STAFF RECOMMENDATION

NCPC File No. 6479

**PATENT OFFICE BUILDING
COURTYARD ENCLOSURE
7th and F Streets, NW
Washington, DC**

October 28, 2004

July concept submission of canopy exterior (left), compared with current preliminary submission of canopy exterior surface (right).

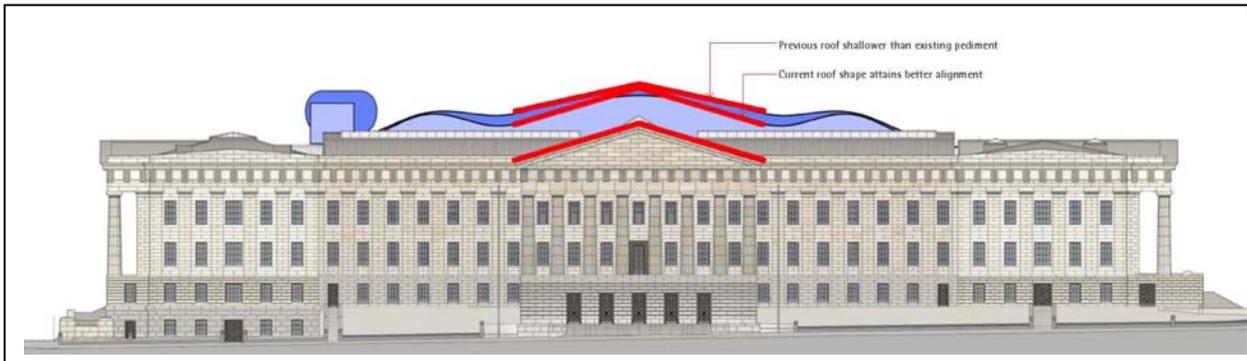
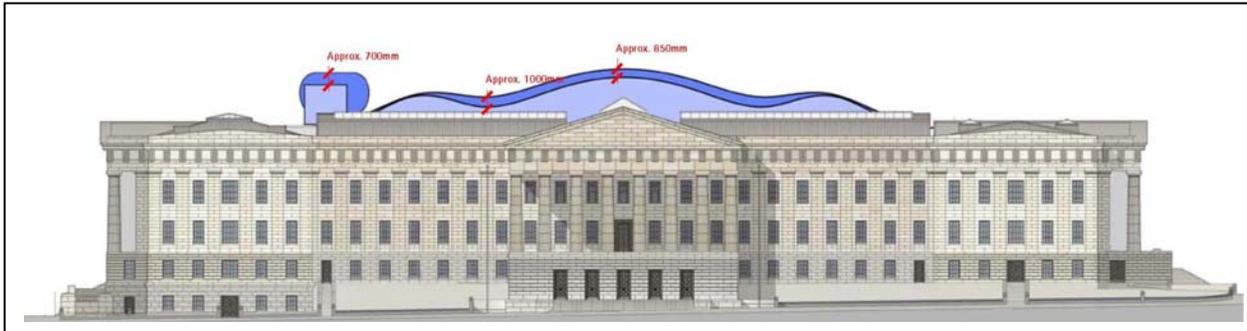
The Smithsonian has responded to the Commission's directive in July to "minimize the profile" of the canopy and "complement the existing building's façade" by removing the projecting grid, which will lessen the prominence of the canopy above the building as the focal point of the 8th Street vista. Even though the glass panels will be arranged in a faceted configuration that will emphasize the reflection of sunlight, the stylistic contrast between the diagonal grid, emphasized

by the fins, and the Greek Revival-style building will be somewhat less pronounced. In addition, the architects have altered the slope of the center vault to more closely mimic the raking cornice of the portico. A relatively slight reduction in height has also been achieved. The apex of the glass surface of the center vault itself has been lowered approximately 20 inches. The rest of the total height reduction of approximately 33 inches is due to the removal of the fins, which measured approximately 13 inches. *The architects have stated that this is the maximum recommended reduction in height in order to retain the structural and functional benefits of the vaults.* The previous center vault (measured to its underside) was approximately 22 feet above the ridge of the portico pediment; the current height is approximately 20 feet above the ridge of the portico pediment. The eight new interior supporting columns have been increased approximately 6 inches in diameter as a result of flattening the canopy.

The slope of the center vault has been modified to make it more similar to the raking cornice of the portico pediment. The exterior fins have been removed to lessen the appearance of the grid and the contrast with the Patent Office. The height of the glass canopy has been reduced approximately 20 inches.

South Elevation (F Street façade), showing revised canopy and cooling tower.

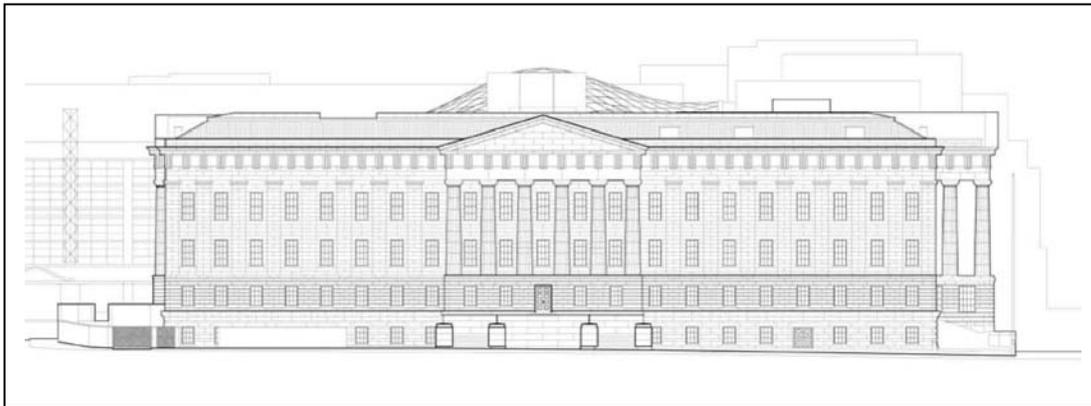
The oval-shaped cooling tower housing has been removed and the support beams lowered. As a result, there is an overall reduction in height of 27 inches. The location has also been shifted to the west to reduce the visibility of the cooling tower from the courtyard.

SI has removed the former oval-shaped housing for the cooling tower. The unit’s supporting beams have been lowered. The current cooling tower, as a result, is 27.5 inches lower in height

than shown in July. *Staff accepts that SI has sufficiently studied the matter and lowered the cooling tower as much as feasible.*

To lessen the view of the cooling tower from the courtyard, the unit has been shifted about 7 feet to the west. In addition, SI also proposes to increase the density of the fritting on the glass canopy in this location to lessen the visibility of the cooling tower from the courtyard. In staff's judgment, these steps will lessen the view of the cooling tower from the courtyard.

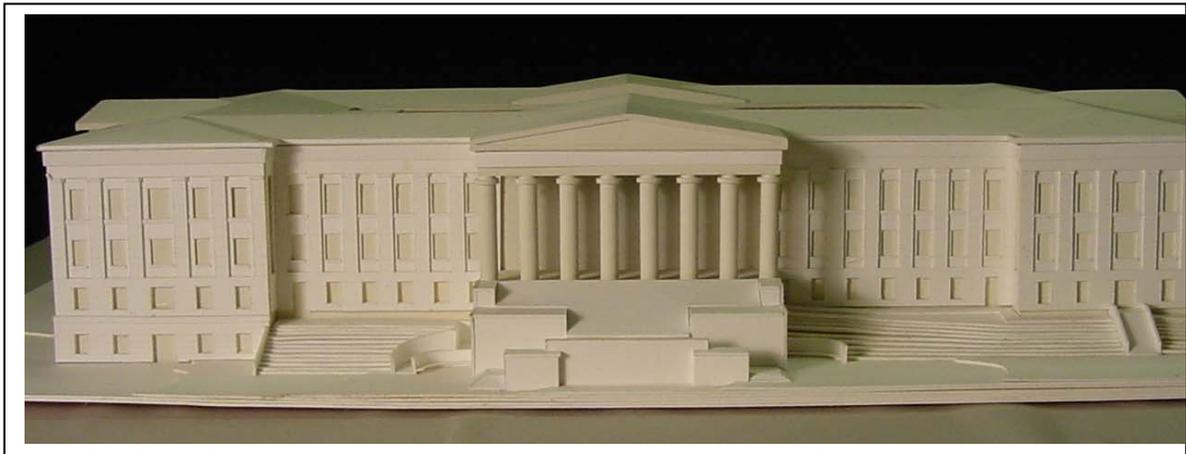
The DC SHPO staff addressed this issue in its September 30 staff report to the D.C. Historic Preservation Review Board (HPRB). The SHPO staff and the HPRB have made the mitigation of the adverse effects of the courtyard enclosure on both the Patent Office and on the L'Enfant Plan a critical element of the Section 106 consultation. The SHPO staff has strongly recommended--and the HPRB has strongly endorsed—that that mitigation include the reconstruction of the monumental cascade of stairs on the south façade. (The SHPO report is attached.)

The stairs were shorn from the Patent Office in 1935 and the current lower level entrance was created when F Street was realigned to eliminate the original street offset at the southwest and southeast corners of the reservation at 7th and 9th Streets. As a mitigation measure for the construction of the MCI Center in 1995, the District and FHWA restored the pre-1935 offset alignment and width of F Street in those two blocks, resulting in the restoration of the space in front of the Patent Office where the steps had previously existed. The District and FHWA paved the way, literally, for the restoration of the south stairs. The Smithsonian participated in those discussions and subsequently, in 2000, studied in-house how the stairs might be reconstructed. They built a model, which is shown below in a photo.

In the staff's judgment, the reconstruction of the south staircase is the only mitigation measure commensurate with the level of adverse effect proposed by the Smithsonian by the enclosure of the courtyard. The reconstruction would restore the earlier physical presence of the Patent Office in its reservation and facing F Street, and significantly improve the view of the Patent Office when seen at the end of the 8th Street by balancing the canopy with a restored base to the building. The HPRB has made a strong case for the reconstructed stair's contribution to the reintegration of the Patent Office in its setting and, as a result, to the building's and the institution's contribution to Downtown.

A pair of handicapped ramps is proposed for the north entrance on G Street, NW.

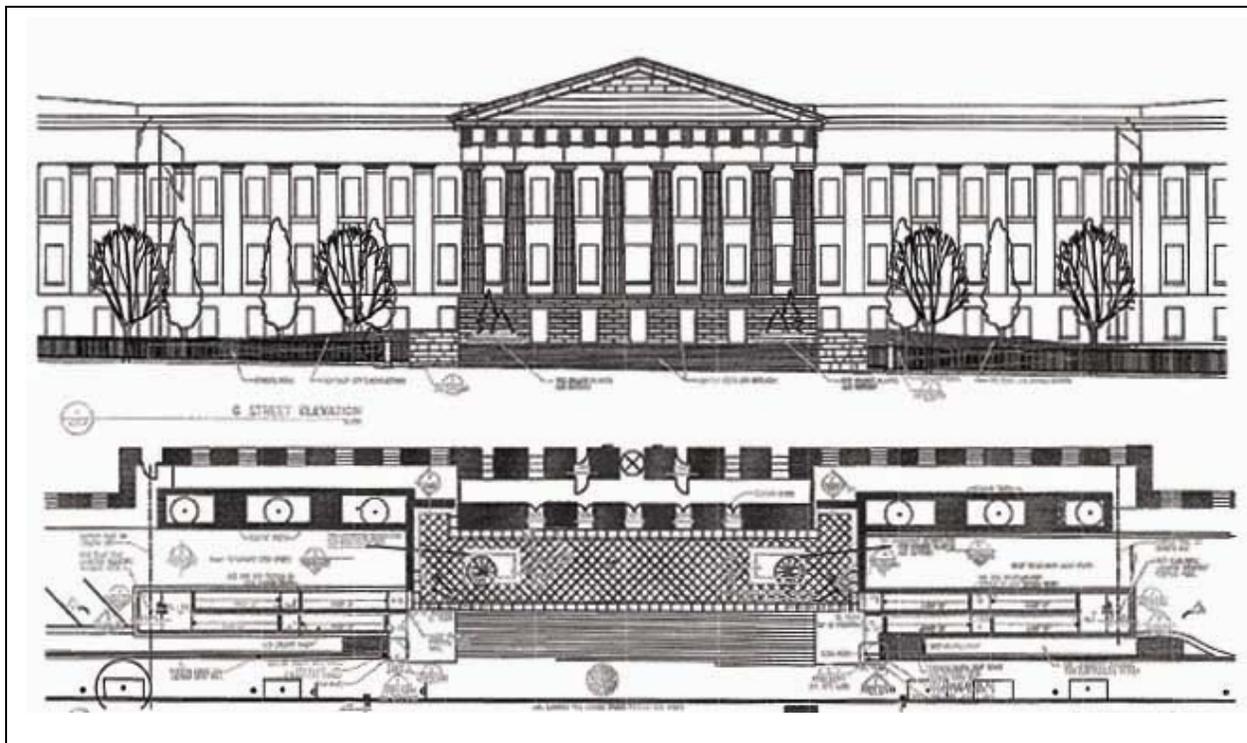
SI has responded to the Commission's request to submit plans and elevations for the handicapped ramps so that staff could ascertain the scope of the proposed alterations within the Commission's review jurisdiction. However, SI has not yet consulted on the ramps through the Section 106 process, and staff recommends that review by the Commission for preliminary site and building plans be deferred until SI can demonstrate that it has considered alternatives and presented the most appropriate one for review and approval. The ramps constitute an adverse effect. *The SI recently met with the SHPO, but the SHPO expects these ramps to become part of the consultation for the project, which includes other agencies and consulting parties.* The staff does not question the need for accessibility from the north façade and notes the proximity of the building to both Gallery Place Metro entrances, but wants SI to ensure that the pair of ramps is configured to minimize adverse effect to the greatest extent possible, since it will be a significant alteration of the building's north façade.

The plan at left and the rendering below show a proposed two-story, free-standing structure in front of western stair tower. The oval-shaped structure, with a surface of extruded aluminum, would house catering kitchen equipment and audio/visual equipment, including a large projection screen.

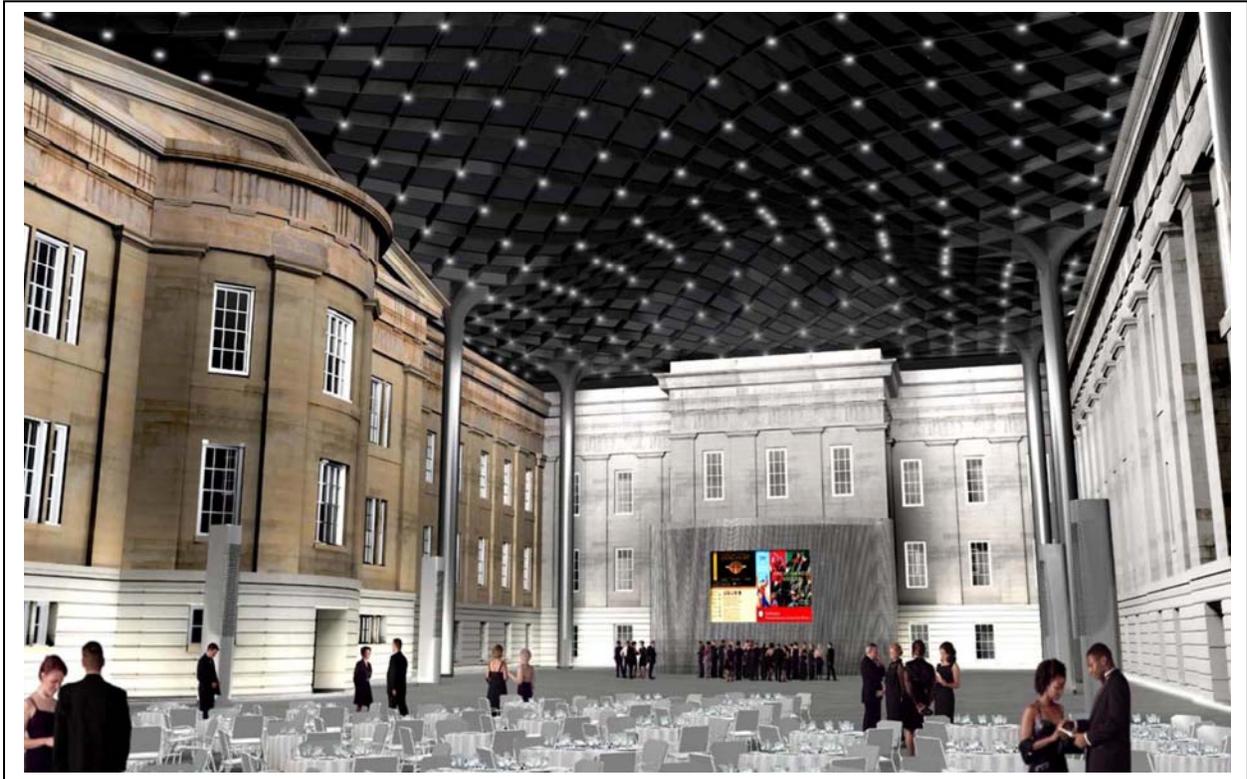
redesign. In particular, staff notes that SI has proposed a two-story, free-standing structure in front of the western stair tower to house catering kitchen equipment and audio/visual equipment and a large projection screen. A perspective rendering and its location in the courtyard plan are shown on the next page.

This structure would be a significant adverse effect. Staff strongly recommends that SI study alternatives to a structure such as this, since it is incompatible with the courtyard's architectural and spatial character, blocking views of the stair tower and the articulation of the interior façade from the courtyard, interrupting the open space of the courtyard, and altering the relative scale of the courtyard features. Utilitarian functions such as these should not be housed in such a prominent and permanent structure. Instead, they should be designed for minimal intervention when in use and housed elsewhere when not in use.
